MELFA Technical News

Subject: About change of component parts of teaching pendant (T/B)

Applicable to: T/B for S series and F series

Old and new difference of the Emergency stop switch.

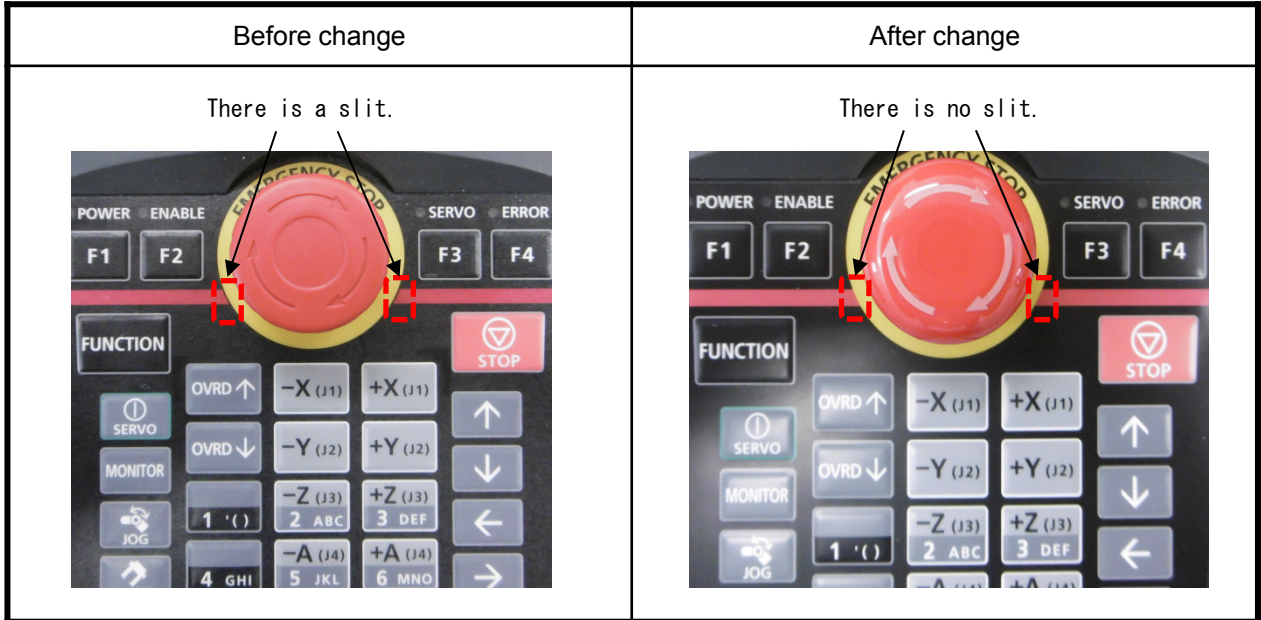
Before change	After change
<p data-bbox="312 488 708 517">Emergency stop switch(Front side)</p> 	<p data-bbox="927 488 1323 517">Emergency stop switch(Front side)</p>
